SAFETY RELATED RECALL

Global Recall Action
Number: H445

Subject: Rear View Camera Image Display	Publication No.: H445
	Model: XE (X760)
	Model Year: 2019
	Date of Issue: 21 September 2023

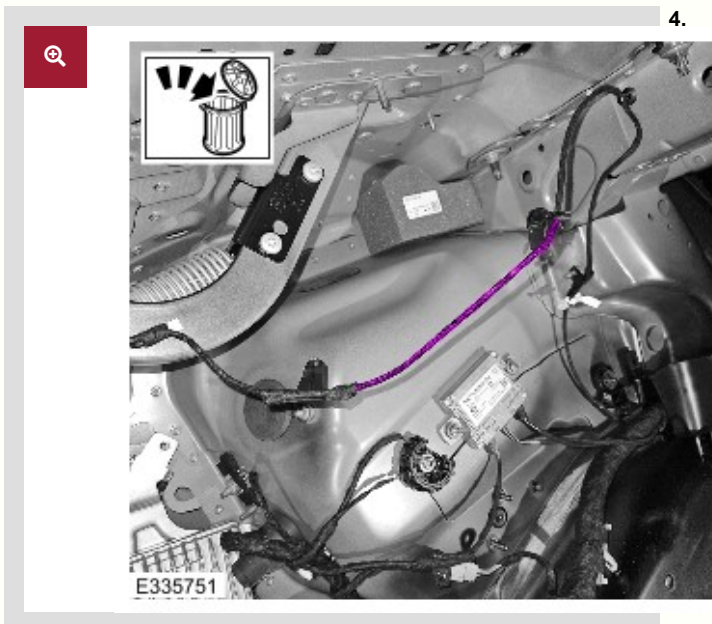
3. Release the 2 wiring harness retaining clips from the left tailgate hinge.

4.

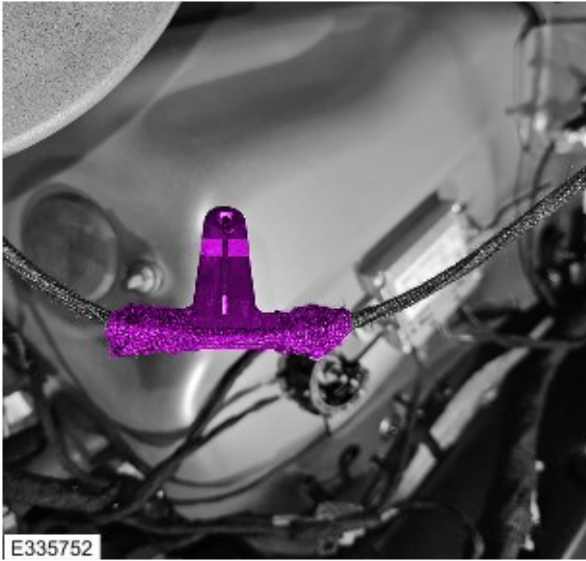
- If the wiring harness has become damaged the repair must be claimed as part of the 'Related Damage Process'.
- If no damage to the wiring harness can be found, continue to diagnose possible rear view camera related concerns as part of a separate repair before continuing with this Service Instruction.

If the Touchscreen displayed a blue screen during step 1, the rear view camera wiring harness, located on the left tailgate hinge, may have become damaged.

- Remove and discard the adhesive tape from the harness and locate the damaged wires.
- Repair any wires that have become damaged (see TOPIx Workshop Manual section 418-02: Wiring Harnesses - Description and Operation - Wiring Harness - Wiring Harness Repair).
